Federal Highway
Administration

Refer to: HNG-14

Mr. C. Richard Briden
Engineering Manager
P&K Pole Products
84 Foundry Street
Newark, New Jersey 07105

You requested individual acceptance letters for each base. This letter is for the hardware tested in PK-103, dated February 1995. A summary of the test data is shown below, and drawings of the cast aluminum shoe base are enclosed.

Figure 2. Manufacturer's Drawing of Test Article

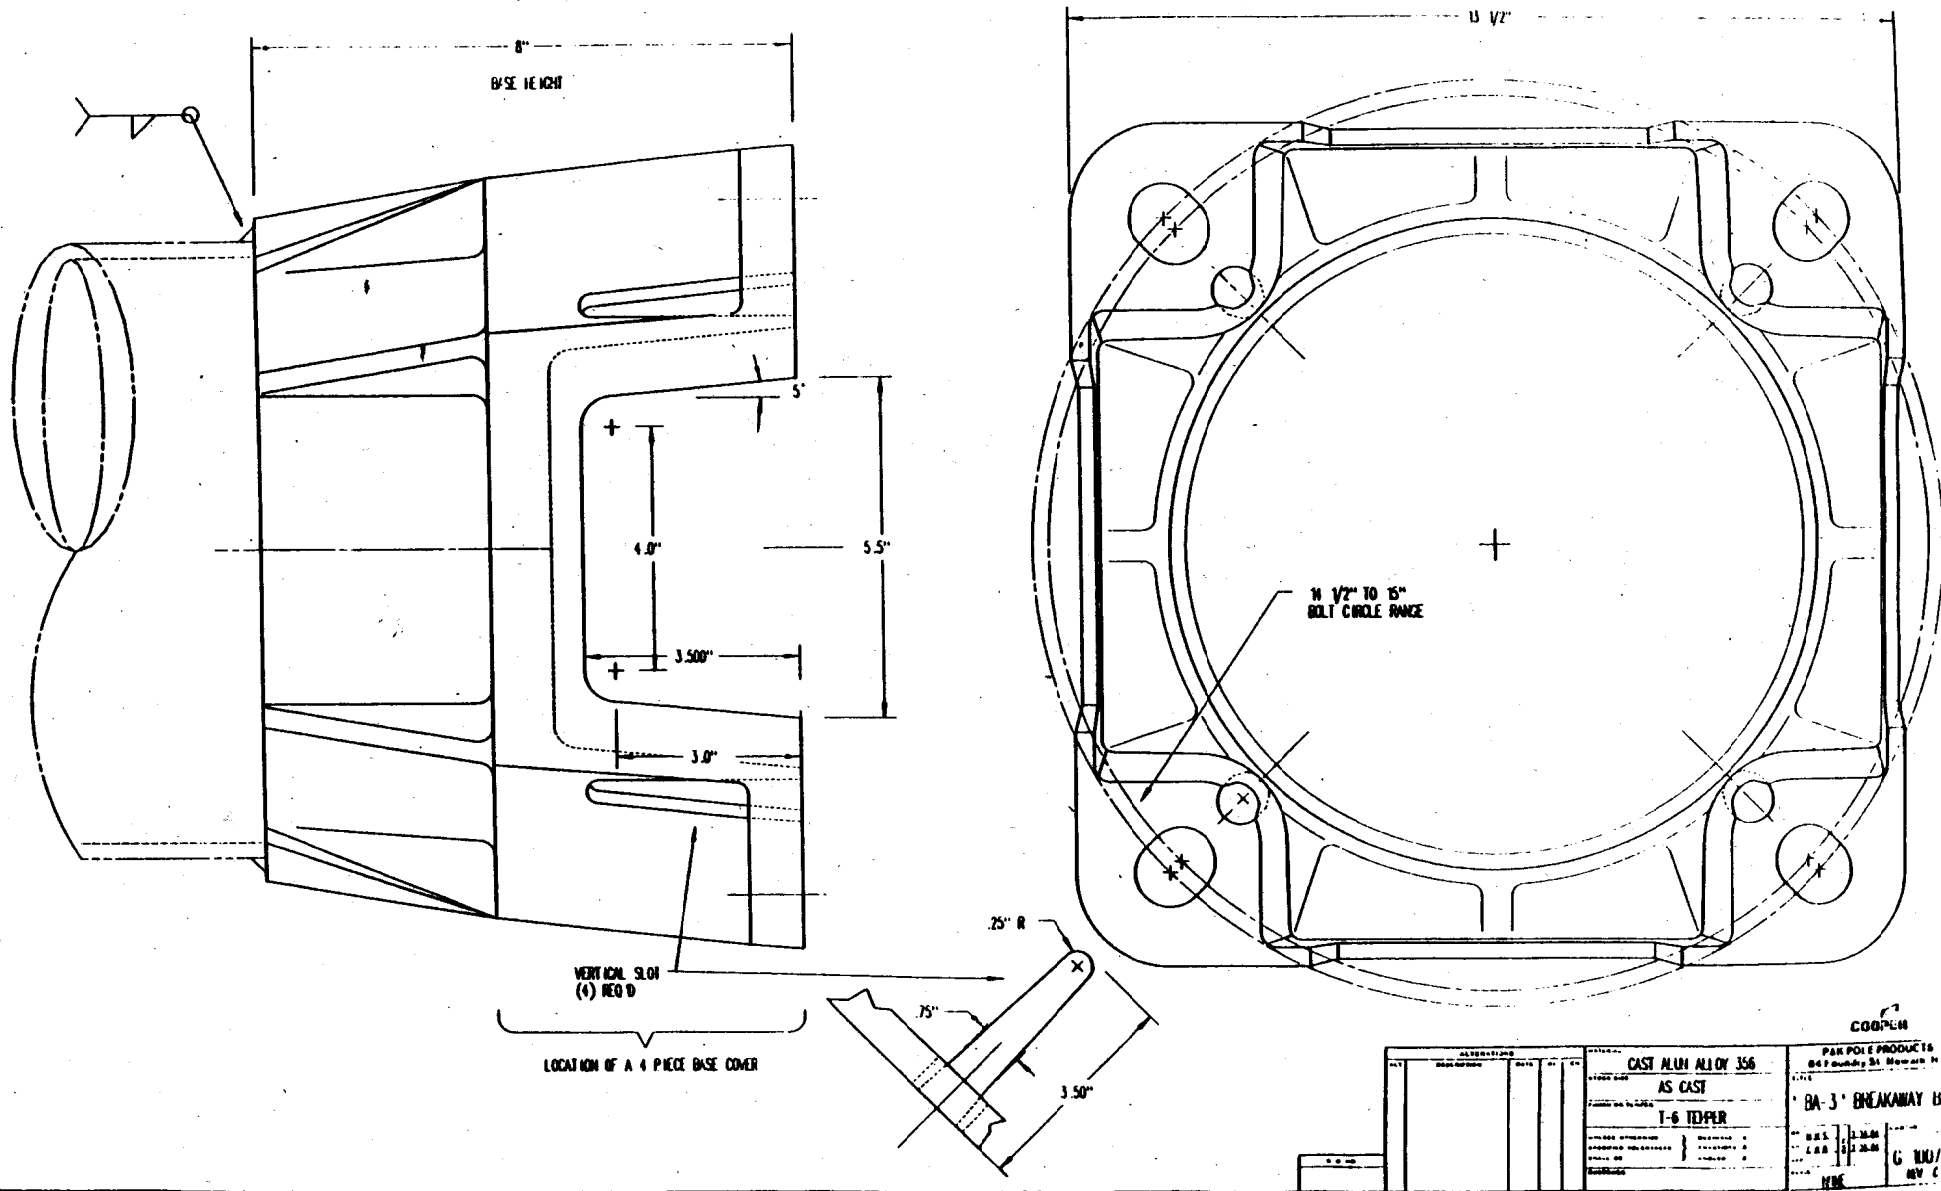
Test Number	PK-103
Support	Aluminum B-104331 Shaft
Pole Wall Thickness, mm (in)	6.35 (0.250)
Pole Butt Diam. and Base Designation P&K Drawing No.	10" BA-3 Breakaway Base C-100764
Bolt Circle Diameter, mm (in)	381 (15)
Test Article Mass, kg (wt, lbs)	224.5 (495)
Mounting Height, m (ft)	15.2 (50.0)
Vehicle Mass, kg (weight, lbs)	820 (1808)
Test Speed, km/h (mph)	35.28 (21.9)
Occupant Imp. Speed m/s (fps)	2.3 (7.7) (@ 0.55 sec)
Vehicle Velocity Change m/s (fps)	2.3 (7.7)
Estimated 100 km/h Occup. Imp. Speed	2.9 (8.9)
Stub Height, mm (in)	64 (2.5)

The results of this test and the high-speed extrapolation meet the change in velocity and stub height requirements adopted by AASHTO and the FHWA. Therefore, the tested aluminum breakaway base described above is acceptable for use on Federal-aid highway projects, within the range of conditions tested, if proposed by a State.

Our acceptance is limited to the breakaway characteristics of the system and does not cover its structural features. Presumably, you will supply potential users with sufficient information on structural design and installation requirements to ensure proper performance. We anticipate that the States will require certification from P&K Pole Products that the hardware furnished has essentially the same chemistry, mechanical properties, and geometry as those used in the tests, and that they will meet the FHWA change in velocity requirements.
